# BEN FRANKLIN BUILDING

Architect ARB	
Registration No.:	Date: 08.24.2018
Drawn by ARB	
Job Number: 1818	
TITLE SHEET	
SCALE:	1 1/2" = 1'-0"

A2.01

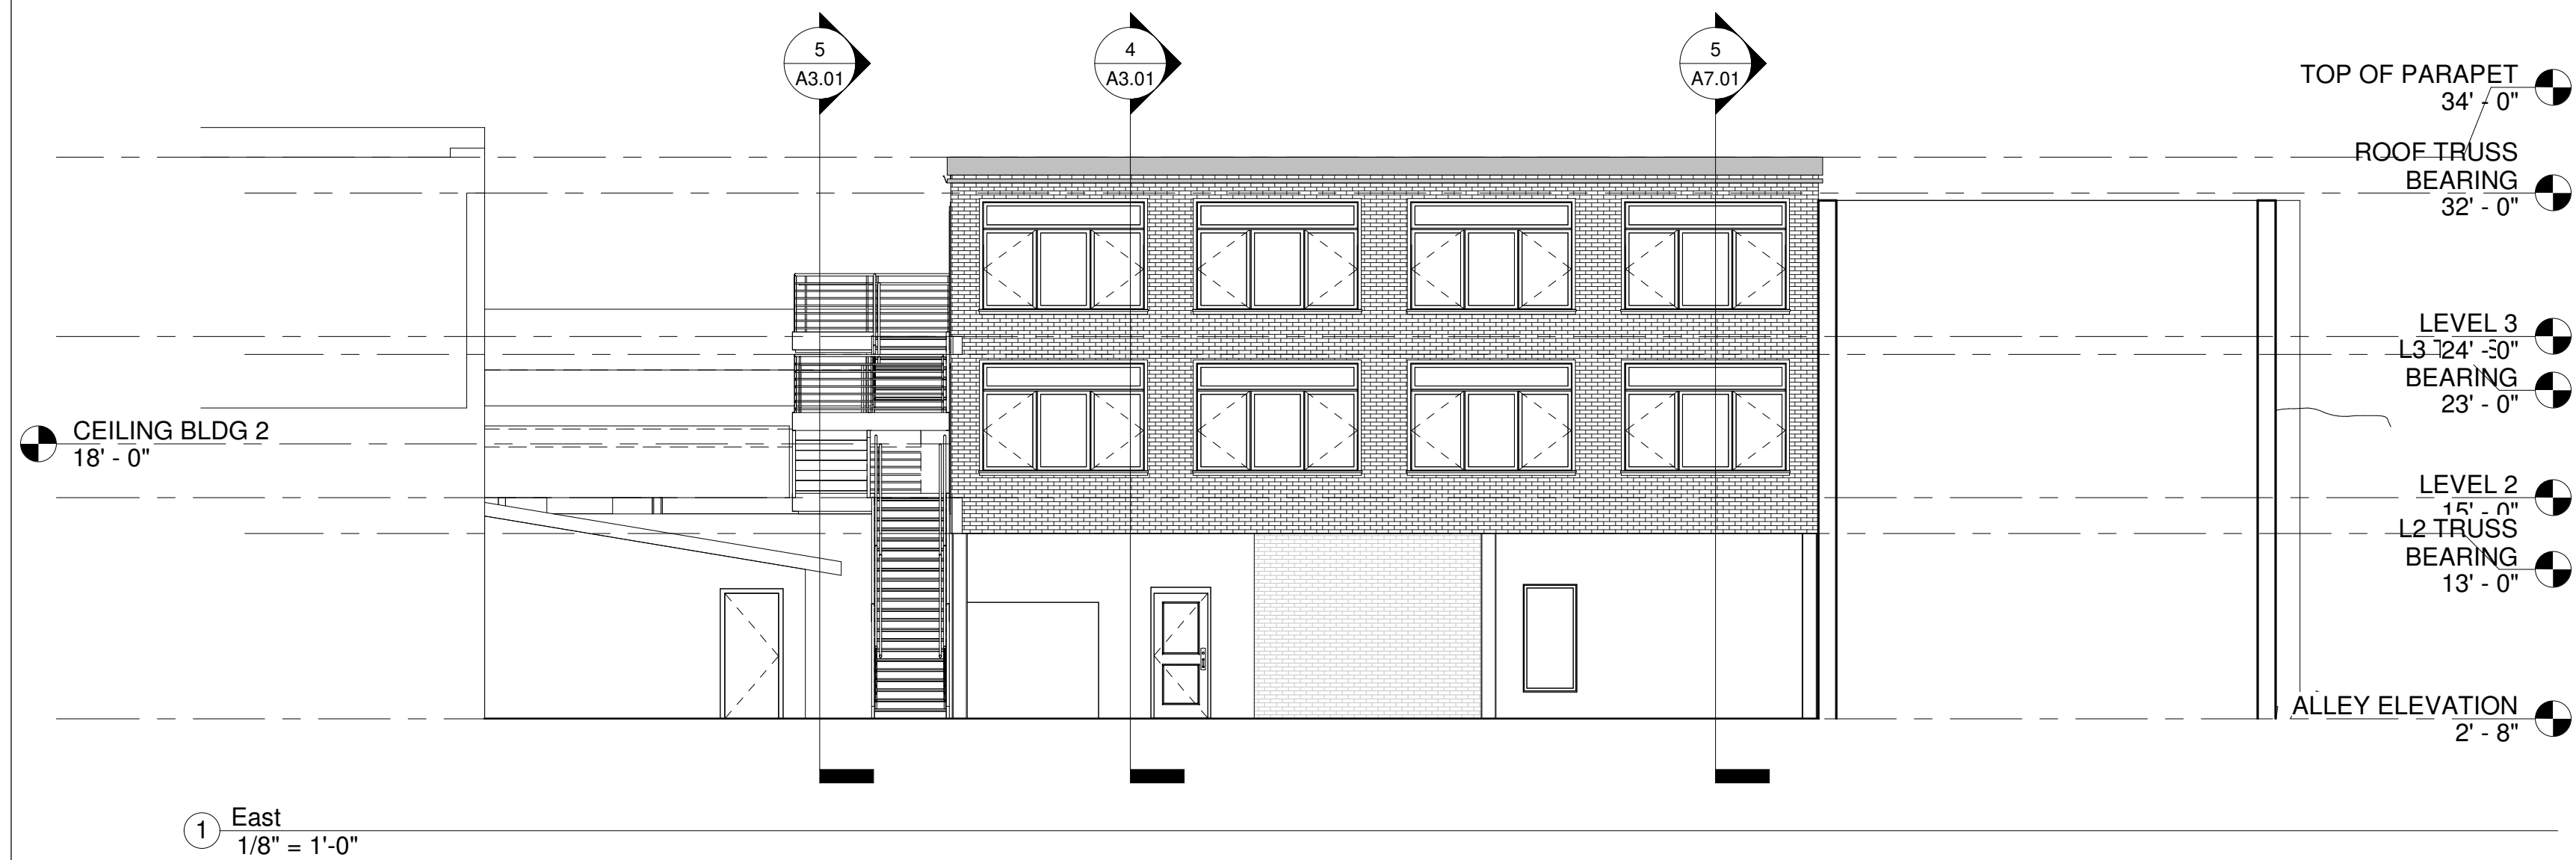
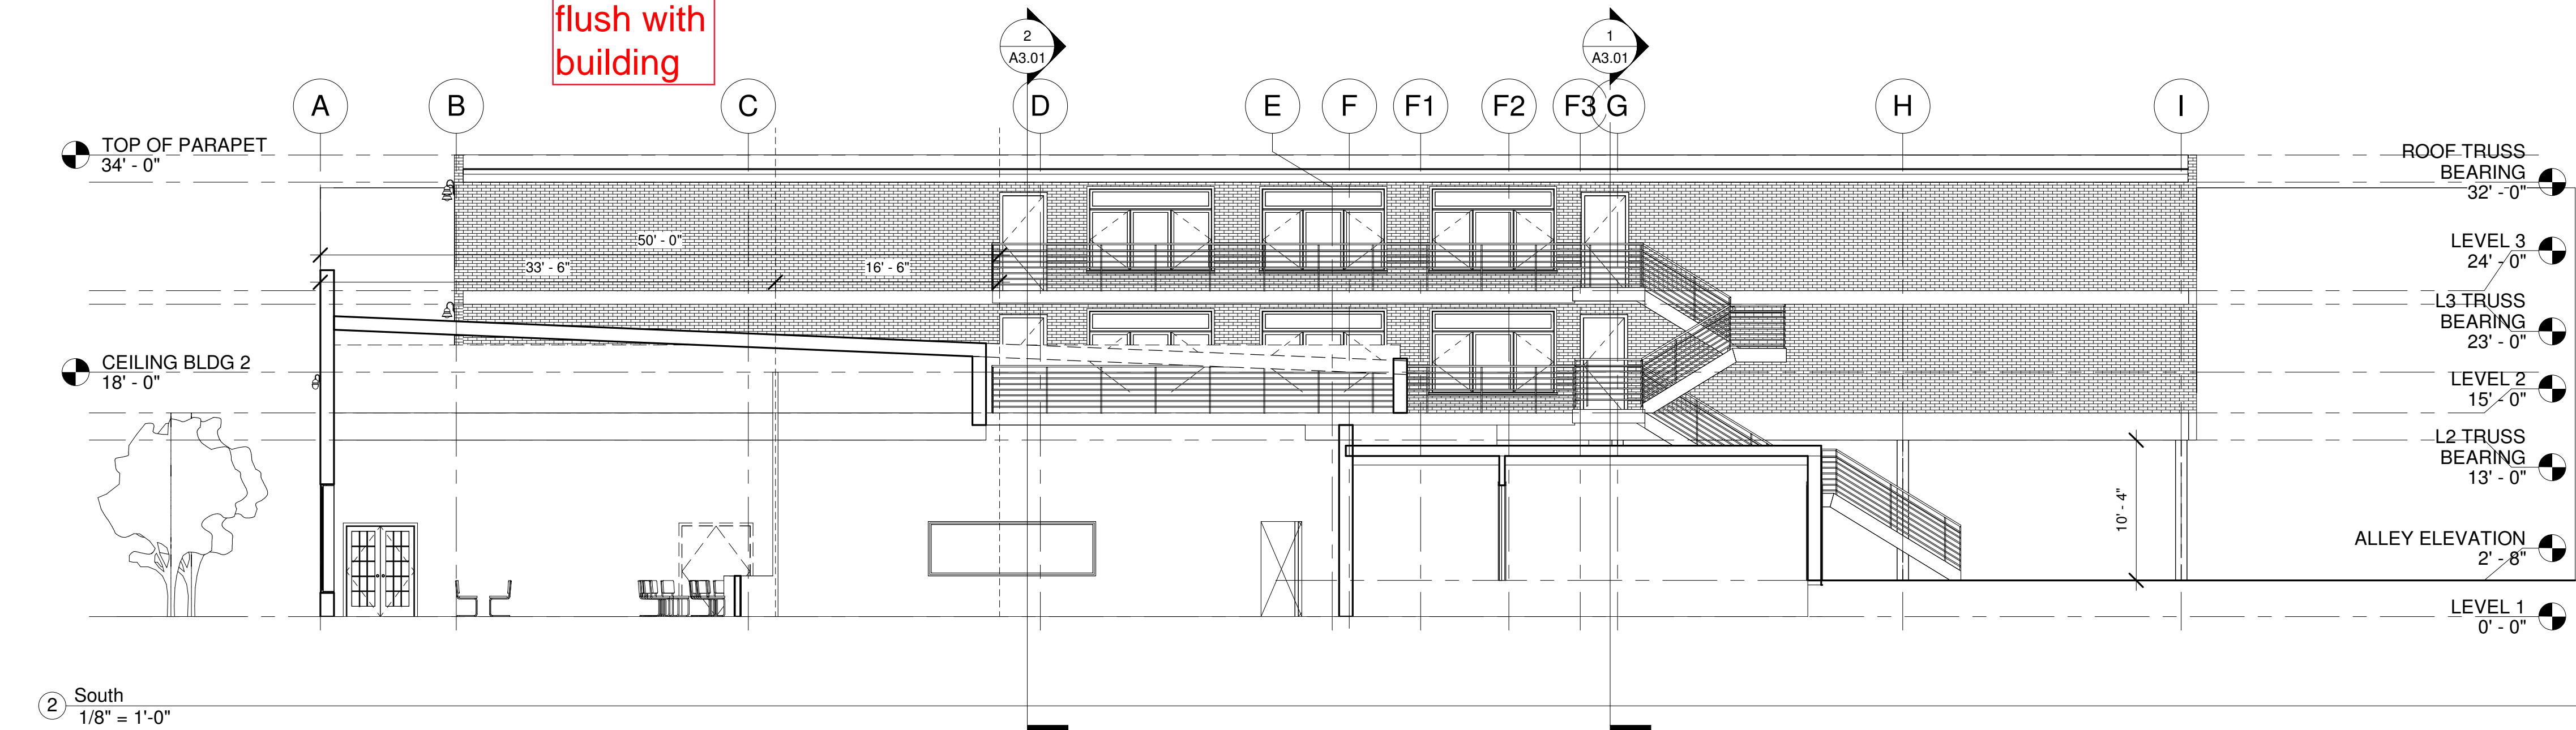
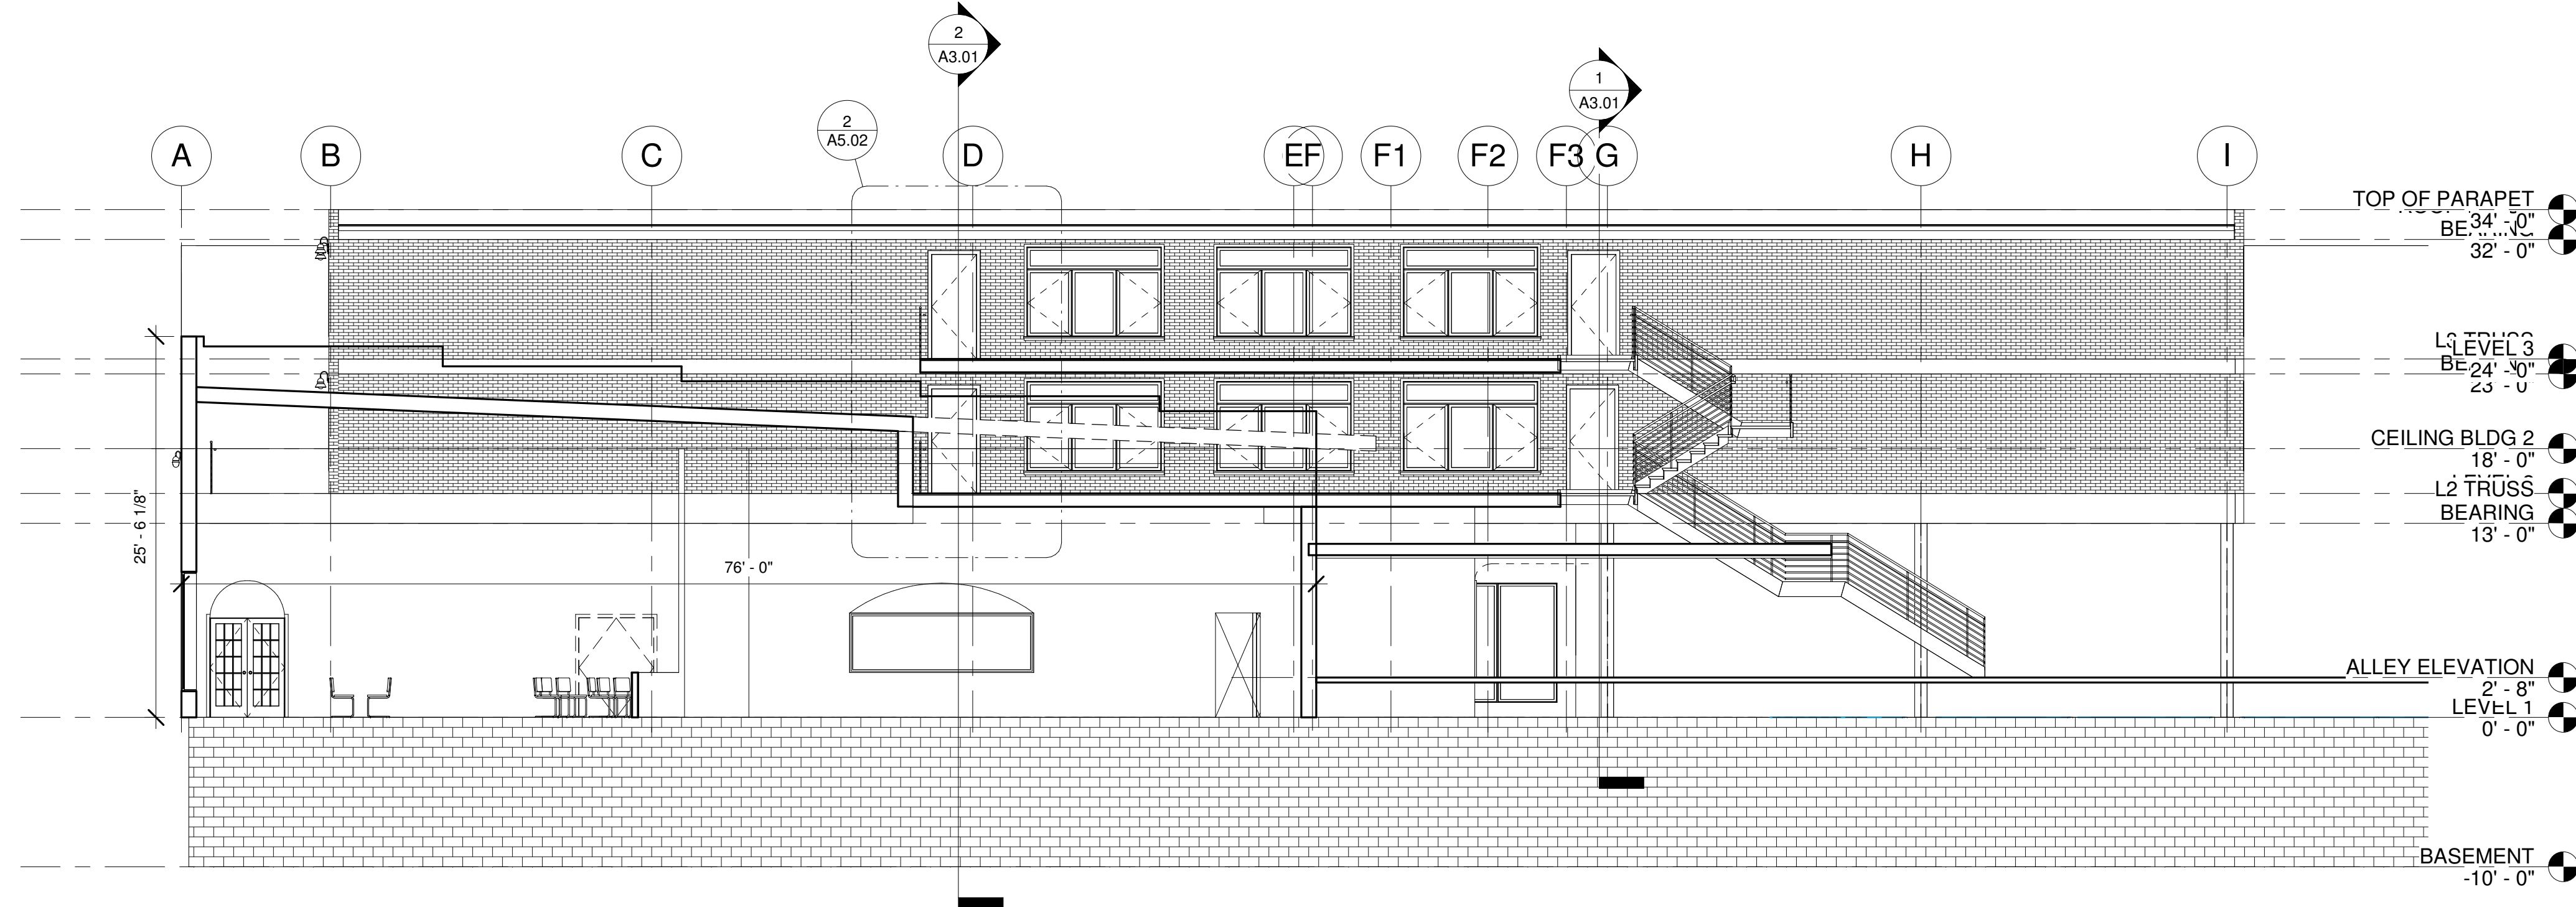
Note as  
flush with  
building

Show as  
garage  
door
